Access Compliance Report

Public Rights-of-Way

(Curb Ramps)

Intersection ID: 45784	Main Street: CRABAPPLE_TREE_LN	Cross Street: LONG_HILL_DR	Location: S
ADA ID: 342E79877D9E	Ramp Type: PerpDiag	Initial Pass/Fail: Fail	Overall Compliance: No
Severity Score: 60			
Codes/Mitigation Info/Possible Solution		Field Measurements/Component Compliance

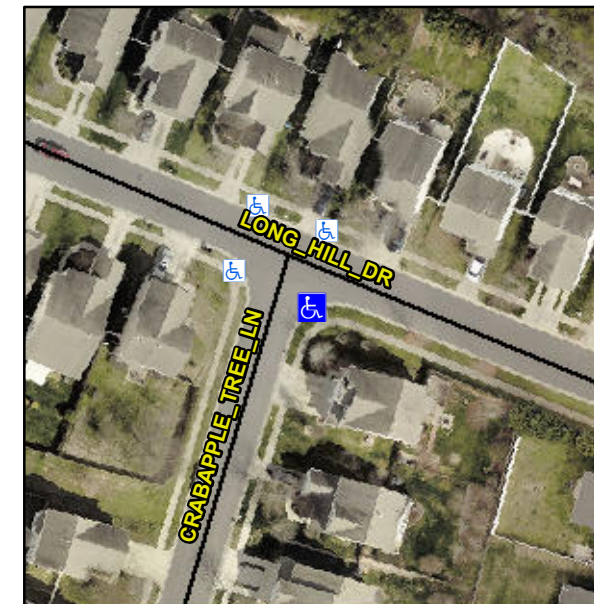
Not Found, R304.5.1, R304.2.2, R304.5.3

Compliance	Description	Data	Compliance	Description	Data
N/A	Ramp Length (in)	71.5	No	Ramp Slope (%)	9.0
No	Ramp Width (in)	30.0	No	Ramp XSlope (%)	6.0
N/A	Flare Type LT	N/A	N/A	Flare Type RT	N/A
N/A	Flare Slope LT (%)	N/A	N/A	Flare Slope RT (%)	N/A
N/A	Flare Traversable LT?	N/A	N/A	Flare Traversable RT?	N/A
N/A	Landing Length (in)	N/A	N/A	DWS Provided?	N/A
N/A	Landing Width (in)	N/A	N/A	DWS Contrast?	N/A
N/A	Landing Slope (%)	N/A	N/A	DWS Length (in)	N/A
N/A	Landing X Slope (%)	N/A	N/A	DWS Full Width?	N/A
N/A	Landing Curb? (Y/N)	N/A	N/A	DWS Offset (in)	N/A
N/A	Shared Landing?	N/A			
N/A	Gutter Ponding?	N/A	N/A	Gutter Slope (%)	N/A
N/A	Gutter Lip Ht (in)	N/A	N/A	Gutter X Slope (%)	N/A
N/A	Painted X Walk1?	No	N/A	Painted X Walk2?	No
	X Walk 1 Direction	To NE		X Walk 2 Direction	To NW
N/A	X Walk 1 Width (in)	N/A	N/A	X Walk 2 Width (in)	N/A
	X Walk 1 Slope (%)	3.1		X Walk 2 Slope (%)	2.5
	X Walk 1 X Slope (%)	1.1		X Walk 2 X Slope (%)	6.3

N/A	Ramp inside XWalk1?	N/A	N/A	Ramp inside XWalk2?	N/A
	Road Slope (%)	5.0	N/A	Clear Space?	N/A
	Road X Slope (%)	4.0	N/A	Clear Space to XWalk (in)	N/A
N/A	Any Obstructions?	N/A	N/A	Storm Grate/Utility Hazard?	N/A
	Obstruction Type			Storm Grate/Utility Type	
		N/A			N/A
			Yes	Surface Condition? (G/P)	Good

Remove & Replace Curb Ramp With Two New Directional Ramps or Equivalent.
